CITY OF ROSEVILLE PLANNING DEPARTMENT STAFF REPORT PLANNING COMMISSION MEETING

July 14, 2005

ITEM VI-A:

DESIGN REVIEW PERMIT, SPECIFIC PLAN AMENDMENT, AND TENTATIVE PARCEL MAP – 751 PLEASANT GROVE BLVD. (HIGHLAND PLAZA SHOPPING CENTER, HIGHLAND RESERVE NORTH SPECIFIC PLAN, PARCEL 40) – FILE#S DRP 04-63, SPA 05-10 & PM 04-22.

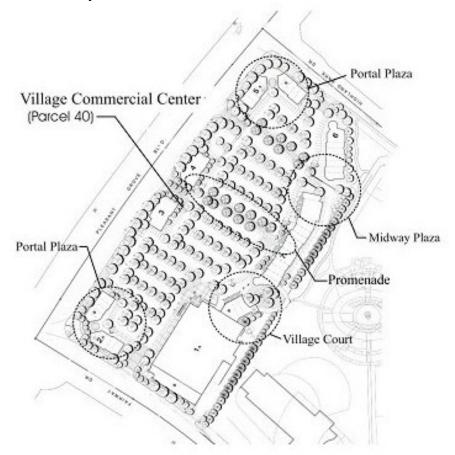
May 9, 2005: Citadel Equities held another meeting to discuss revisions made to the site plan in response to comments made by neighbors at the previous meeting, and to discuss the results of additional traffic analysis. Revisions to the site plan included removal of a building adjacent to Highland Park Drive, incorporation of a pedestrian plaza area adjacent to the Highland Park Drive entrance, additional pedestrian connections from the public sidewalks into the center to avoid pedestrians having to use the driveway entrances, and an additional pedestrian connection to Central Park (Attachment 6). Neighbors were concerned to learn the driveway on Highland Park Drive would be the entrance for truck traffic, and strongly argued that the driveway should be removed to reduce traffic on Highland Park Drive.

on Highland Park Drive.

Staff believes that the extensive public outreach by the applicant and participation from the adjacent neighbors on this project has resulted in significant project improvements. The developer has met all the neighbors concerns, except the removal of the entrance on Highland Park Drive. The resultant site plan is shown below, with key features called out.

Considering the modifications to this driveway and the lack of compelling reasons to remove the driveway, staff supports the site plan as proposed.
